Regarding: 05V-256

Technical BULLETIN

RECALL

All XVS11 (V Star 1100 Custom) and XVS65 (V Star Custom) FACTORY MODIFICATION CAMPAIGN

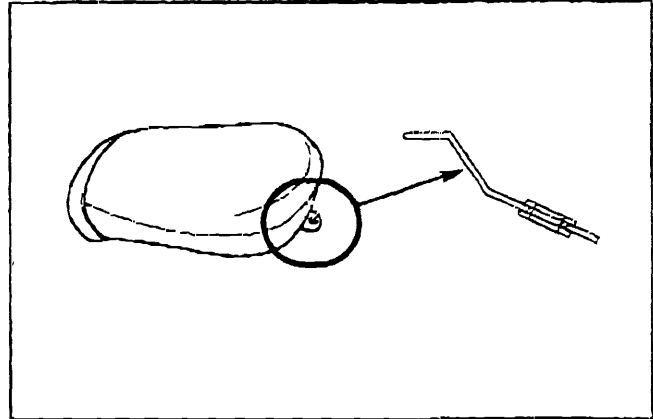
3. Install the new seat bracket from the kit using the original bolts and washers. The new bracket has a larger hole for the grommet.

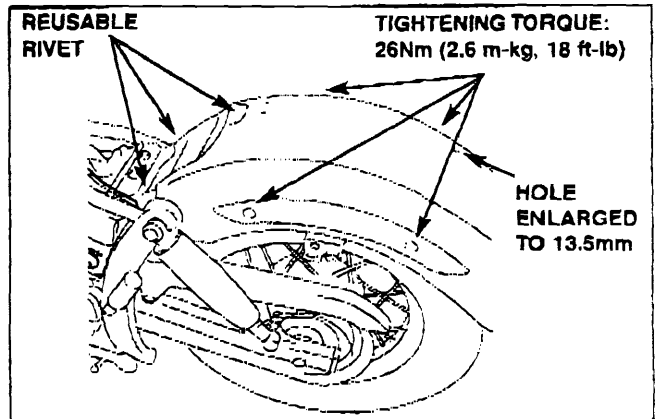
6. If the motorcycle was not previously modified according to the original Technical Bulletin M2005-003, use a step drill or another appropriate tool to carefully enlarge the hole on the rear fender for the passenger seat stud bolt to 13.5mm. Smooth the edges of the hole.

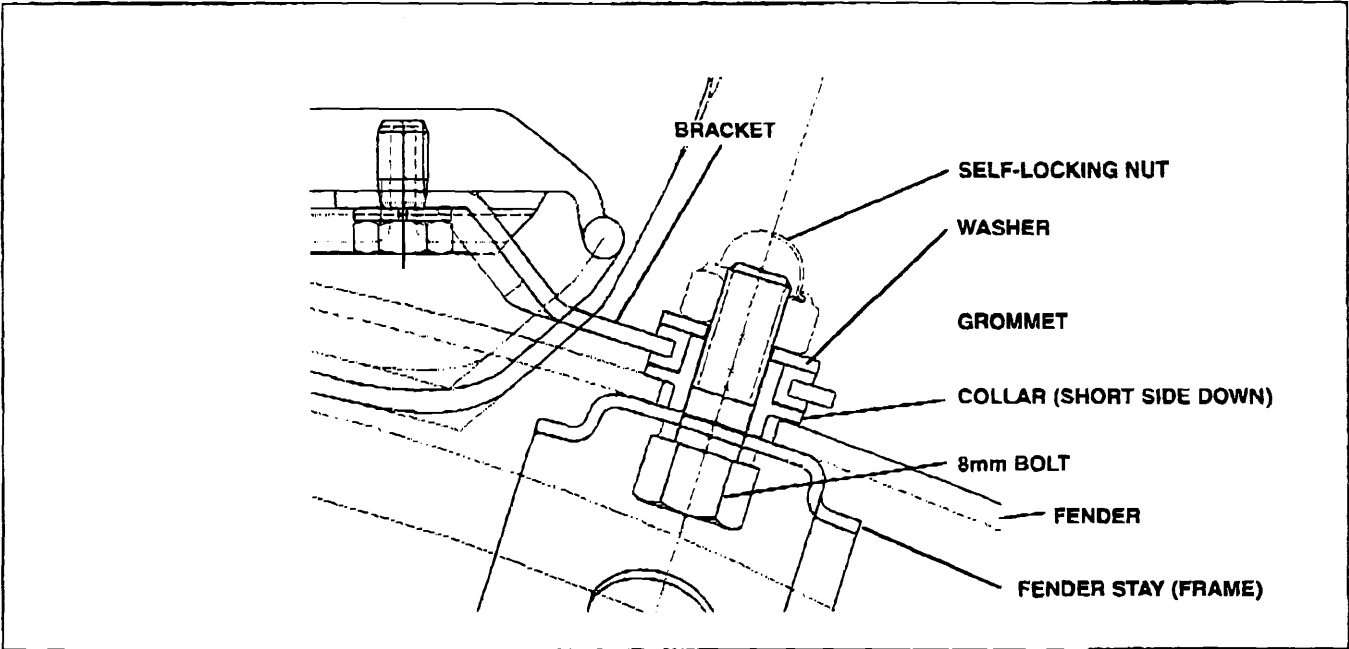
9. Install the new 8mm bolt from the kit up through the hole in the frame and fender. Put the new collar from the kit over the bolt, with the shorter end down. **Make sure the collar fits inside the hole and that it bottoms against the fender stay (see the illustration on page 8).**

10. Put the new bracket with grommet of the modified passenger seat (installed in step 4 for Both Models on page 4) over the collar. Install the new washer and the self-locking nut on the bolt. Tighten the nut to specification.

Tightening Torque: 13Nm (1.3m-kg, 9 ft-lb)

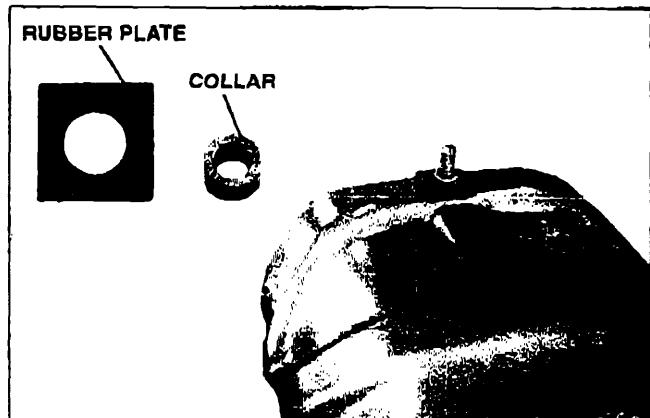
4. Put the collar and rubber plate (spacer) from the kit over the stud on the new fender support. Install the fender support under the fender, then the fender stays, and finger-tighten the four bolts (two each side) which hold the support in place. **Make sure the collar passes through the hole in the fender and that it is bottomed against the fender support, not the rubber plate.**

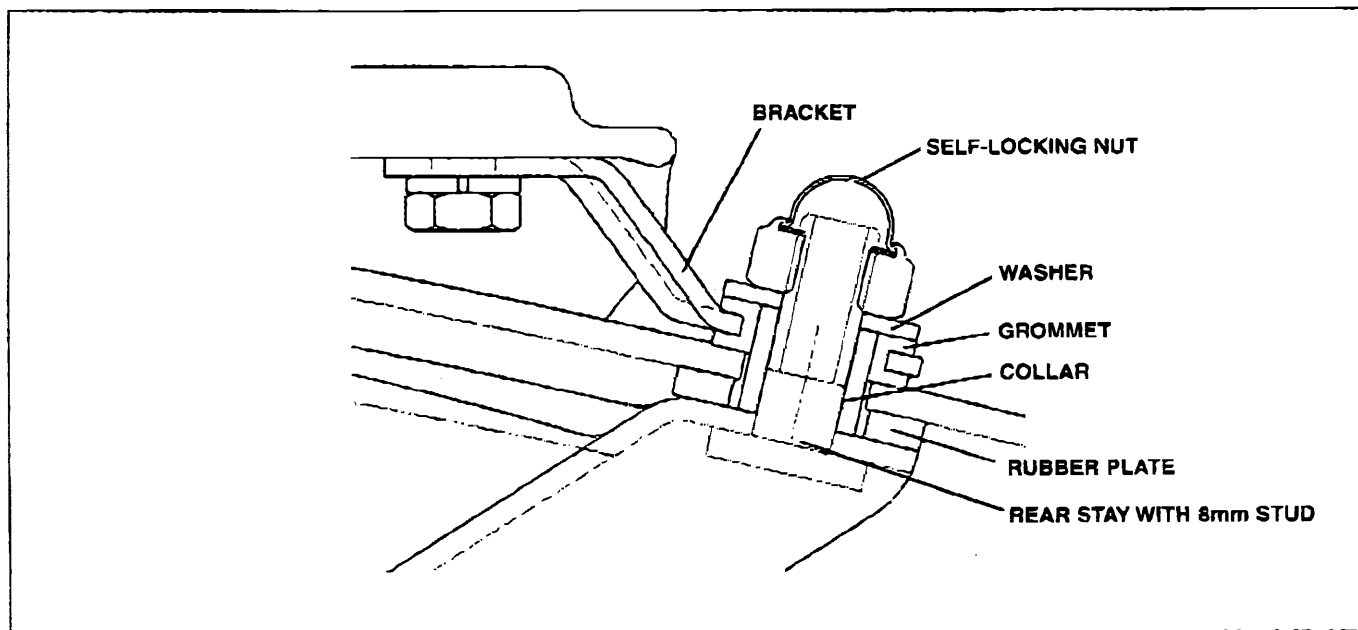
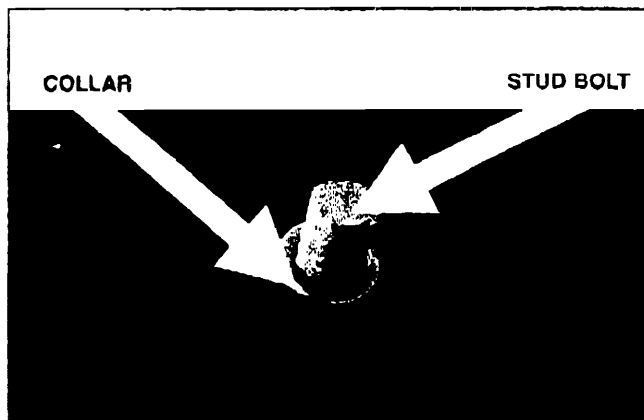
5. Reinstall the fender on the motorcycle and tighten all eight fender stay bolts to specification.
6. Reconnect the taillight harness coupler and reinstall the right-hand side cover.
7. Reinstall the rider seat bracket and the rider seat.
8. Put the new bracket with grommet of the modified passenger seat (installed in step 4 for Both Models on page 4) over the collar and stud bolt. Install the new washer and the self-locking nut on the bolt. Tighten the nut to specification.

Tightening Torque: 13Nm (1.3m-kg, 9 ft-lb)

OWNER'S MANUAL MODIFICATION (ALL UNSOLD UNITS)

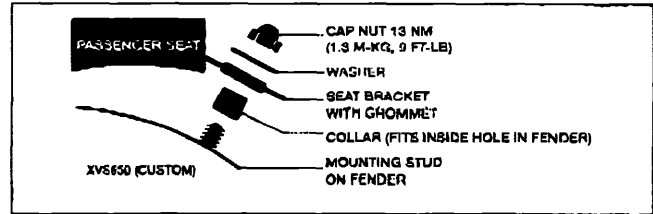
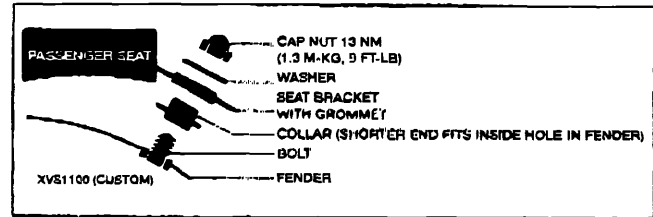
The Owner's Manuals describe removal and reinstallation of the passenger seat. If you are modifying an unregistered unit, put a sticker for the appropriate model on the page covering the Passenger Seat (check the index in the back if you have trouble locating the right page). Some stickers are enclosed with this bulletin. Contact your RTA if you need more.
